PIC18F47J53 Family Silicon Errata and Data Sheet Clarification

The PIC18F47J53 Family devices that you have received conform functionally to the current Device Data Sheet (DS39964B), except for the anomalies described in this document.

Data Sheet Clarifications

The following typographic corrections and clarifications are to be noted for the latest version of the device data sheet (DS39964B):

FIGURE 2-3 FREQUENCY vs. ESR PERFORMANCE FOR SUGGESTED VCAP

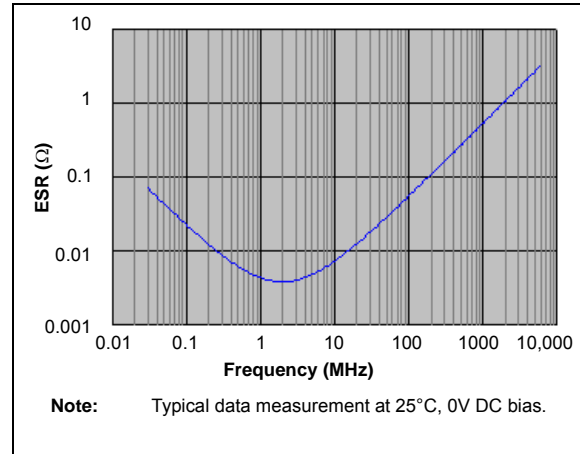
Section 2.4 “Voltage Regulator Pins (VCAP/VDDCORE)” has been replaced with a new and more detailed section. The entire text follows:

On “F” devices, a low-ESR ($< 5\Omega$) capacitor is required on the VCAP/VDDCORE pin to stabilize the voltage regulator output voltage. The VCAP/VDDCORE pin must not be connected to VDD and must use a capacitor of $10\ \mu\text{F}$ connected to ground. The type can be ceramic or tantalum. Suitable examples of capacitors are shown in [Table 2-1](#). Capacitors with equivalent specification can be used.

Designers may use [Figure 2-3](#) to evaluate ESR equivalence of candidate devices.

FIGURE 2-4 DC BIAS VOLTAGE vs. CAPACITANCE CHARACTERISTICS

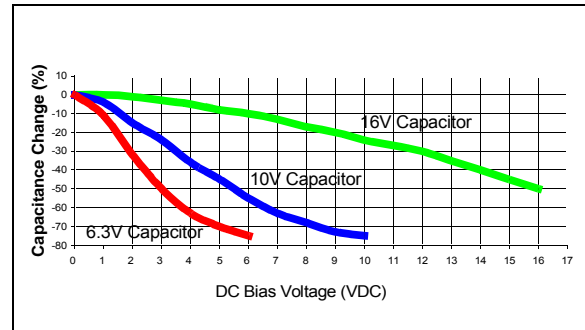
In addition to temperature tolerance, the effective capacitance of large value ceramic capacitors can vary substantially, based on the amount of DC voltage applied to the capacitor. This effect can be very significant, but is often overlooked or is not always documented.

A typical DC bias voltage vs. capacitance graph for 16V, 10V and 6.3V rated capacitors is shown in [Figure 2-4](#).

When selecting a ceramic capacitor to be used with the internal voltage regulator, it is suggested to select a high-voltage rating, so that the operating voltage is a small percentage of the maximum rated capacitor voltage. For example, choose a ceramic capacitor rated at 16V for the 2.5V core voltage. Suggested capacitors are shown in [Table 2-1](#).
